FW: City of Bandon - Traffic Intersection / Impact Clarification

9-28-23 Applicant's Response to Public Testimony

Location	US101; OREGON COAST HIGHWAY NO. 9; 1.02 miles south of 18th SW Street	Site Name	Bandon (06-004)
		Installed	September, 1954

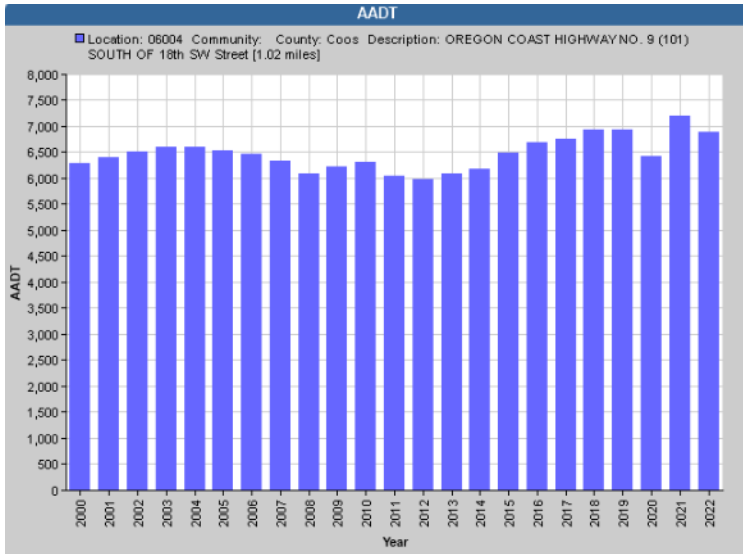
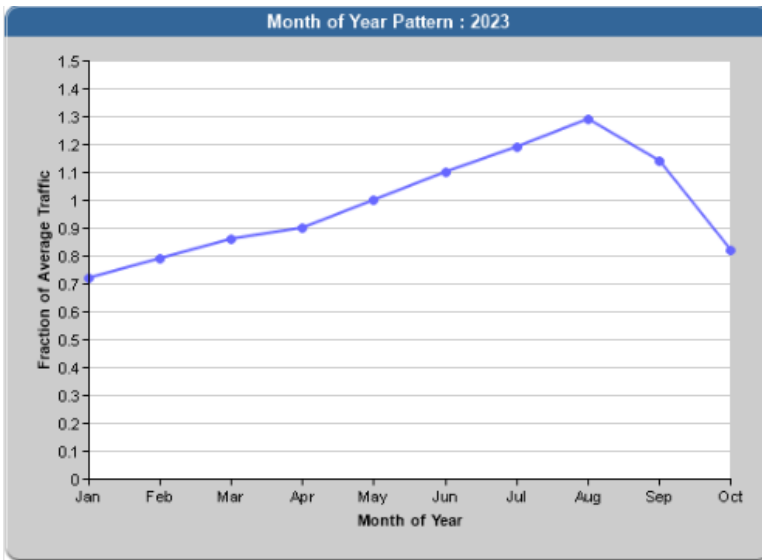
Some of the community comments that have arisen have implied that 2021 was a COVID year and any traffic information that has been conducted during COVID is not a true representation of actual traffic patterns. In your professional opinion, has ODOT seen any change in the current street standards & traffic impacts based on ODOT's own standards and thresholds post COVID for these intersections (or any intersections in the City of Bandon)? We have adjusted our projections +26% to account for Post-COVID traffic impacts (and still fit within standard).

Hope this all helps! Data for 2023 is ongoing and we do not have an official AADT yet, but I have attached another snip below showing average traffic data from a monthly standpoint in 2023 as well for reference.

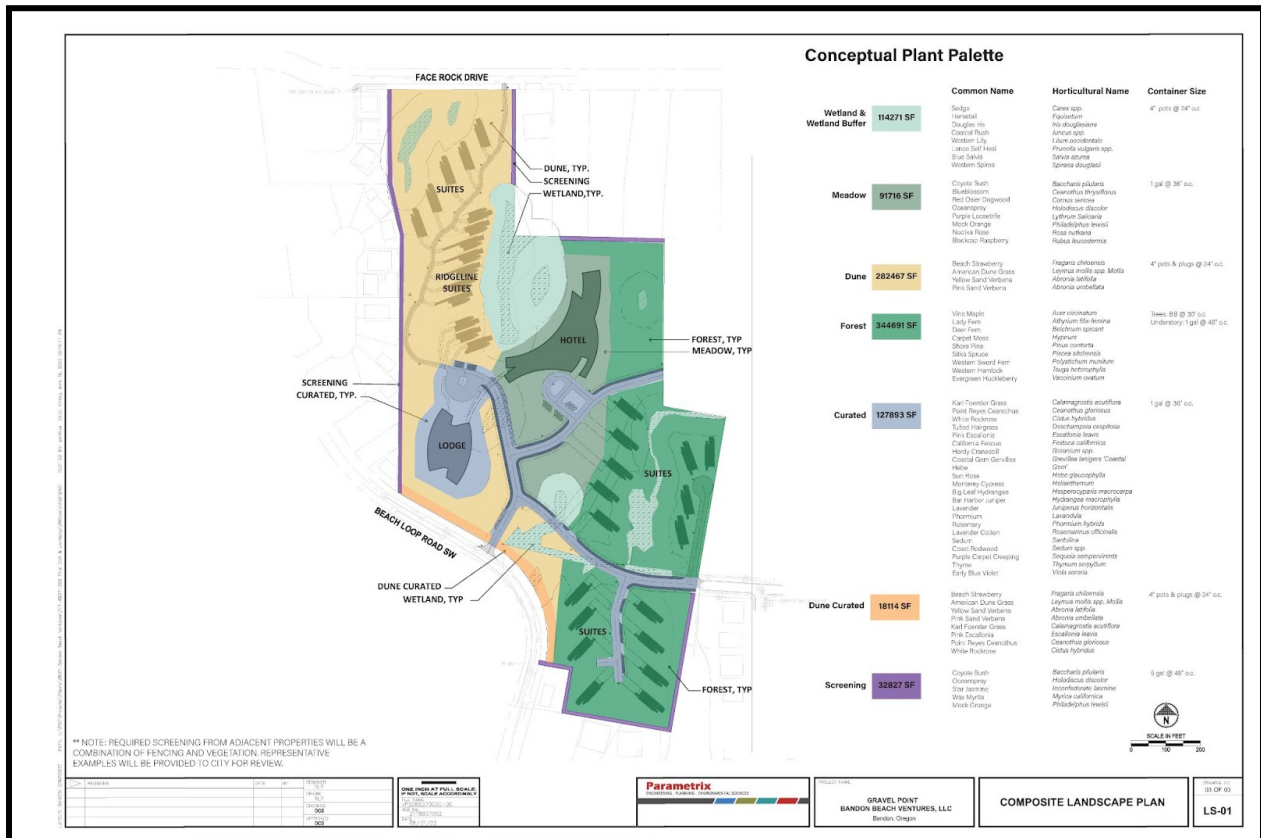
FINDING: The applicant's plan does not show compliance with screening features such as storage areas, trash enclosures, transformers, generators, propane tanks and other appurtenant structures. The applicant shall submit plans as to how they intend to meet this requirement. Staff recommends the hearing be continued or the record be held open for the applicant's submittal of plans demonstrating compliance. Alternatively, because the record does not include any plans as to how this criterion is met, the Planning Commission may deny the proposal.

Applicant's Response: The revised plans show a screened area for trash enclosures and receiving. HVAC equipment will be located in the basement floor of the structure. Propane tanks will likely be buried, and those locations will be determined when approval of the Conditional Use is granted and engineering starts. All features are required to be reviewed during Zoning Compliance for full compliance.
